MEMORANDUM

DATE: February 18, 2021

SUBJECT: Loker Turf Field Stormwater Management Assessment for Phosphorus Removal

Figure 1. Alternative 1 drainage area (highlighted in pink) could be graded so that water would flow into the green island nearest the subsurface infiltration chambers.

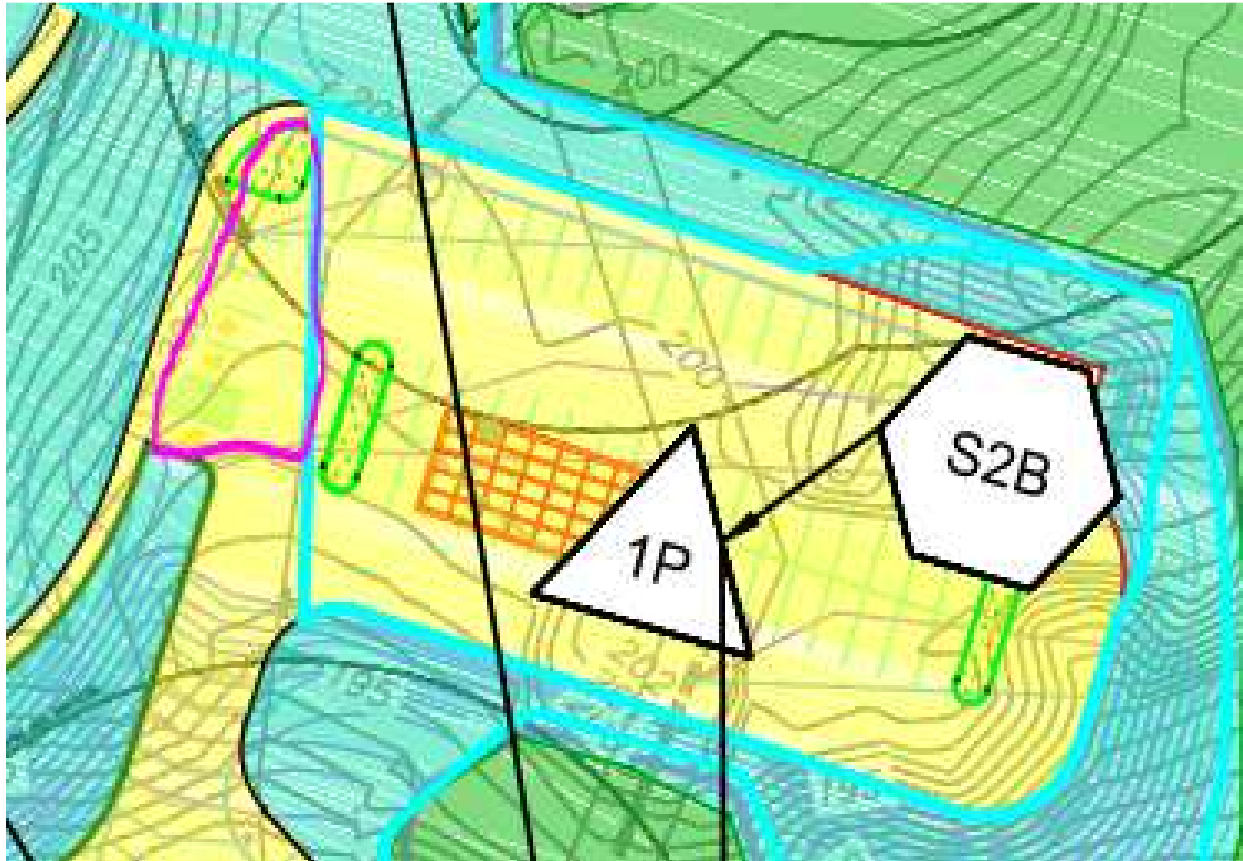
Alternative 1 would include managing stormwater from the roughly 1,300 square feet (0.03 acres) of the parking lot that is not currently designed to drain to the subsurface chambers by converting

one of the greened islands in the parking lot to a bioretention planter with curb cuts to allow stormwater to flow in (Figure 1). This alternative would provide an additional 0.02 kg/yr of P removal (see Table 2).

Alternatively, the parking lot could be redesigned to allow this portion of impervious cover to drain to the proposed subsurface chamber that is designed for the rest of the parking area. The P load reduction would be the same for either option.

Figure 2. Alternative 2A drainage area (highlighted in red) could be graded so that runoff would flow into a water quality swale on each side of the road or to one side of the road for treatment before reaching the stormwater collection system.

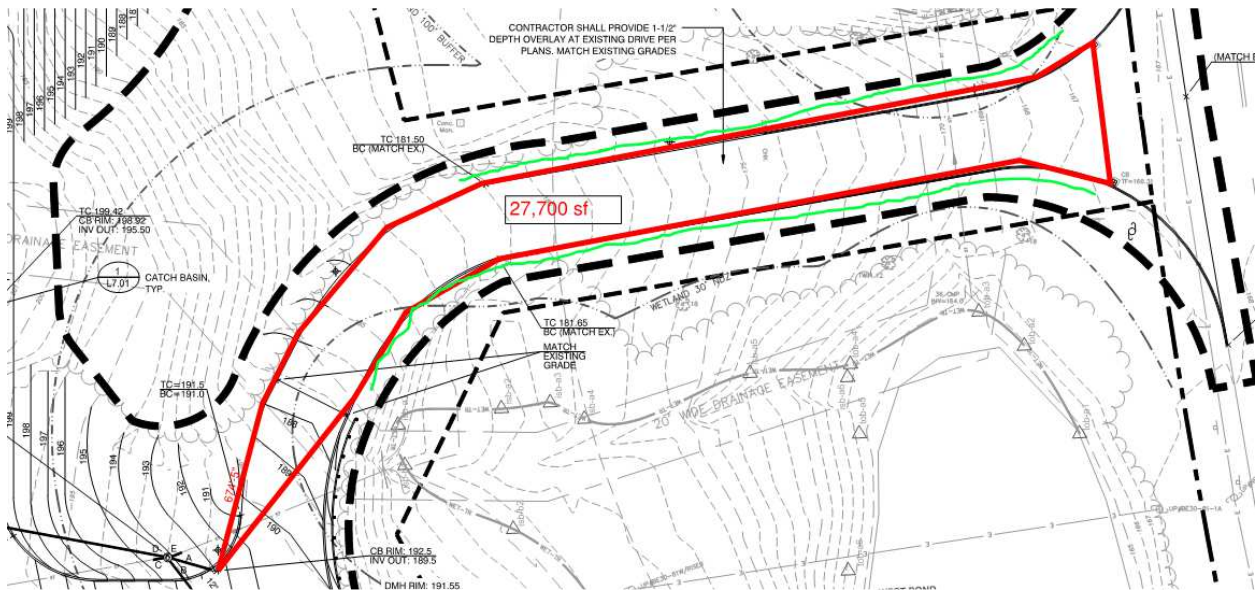
Alternative 2A would include managing stormwater from the access road leading from Commonwealth Road to the proposed parking lot with water quality swales on each side of the road or one side of the road, depending on final grading and design goals (Figure 2). This alternative would provide an additional 0.01 kg/yr of P removal (see Table 3).

Figure 3. Alternative 2B drainage area (highlighted in red) would flow to a grass swale on each side of the road which would flow to a rain garden for treatment before reaching the existing stormwater collection system.

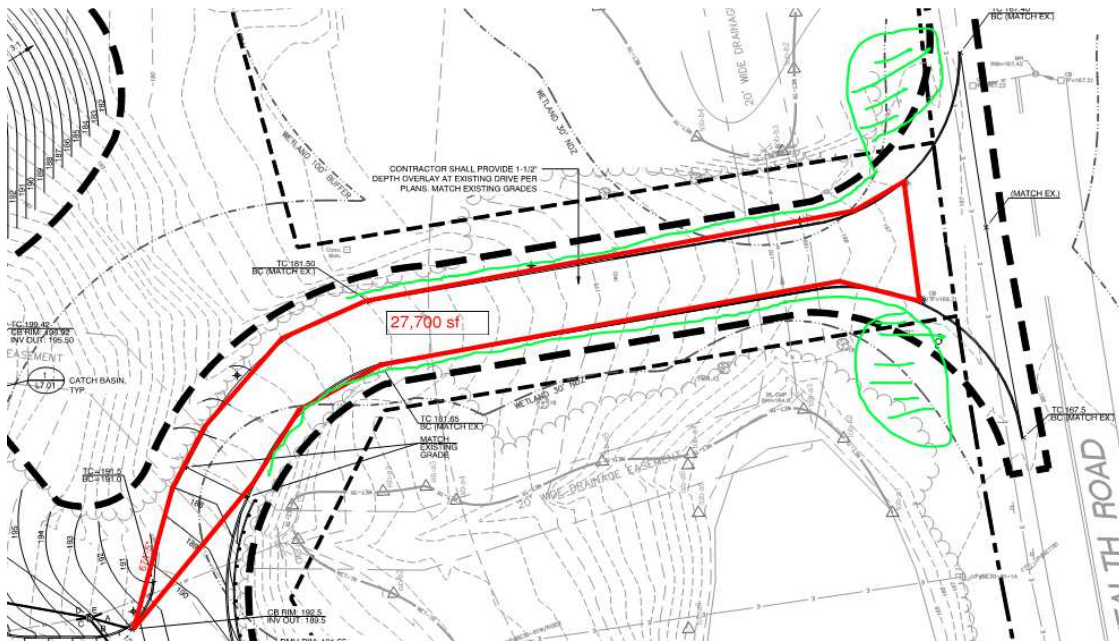
Alternative 2B would include managing stormwater from the access road leading from Commonwealth Road to the proposed parking lot by constructing grass swales to drain to rain gardens for treatment before ultimately flowing to the existing stormwater collection system (Figure 3, Figure 4). This alternative would provide an additional 0.4 kg/yr of P removal (see Table 4) offering better P removal than Alternative 2A. However, high groundwater was noted in the soil investigation, which may prohibit infiltrative rain gardens; further soil testing would be required prior to final design.
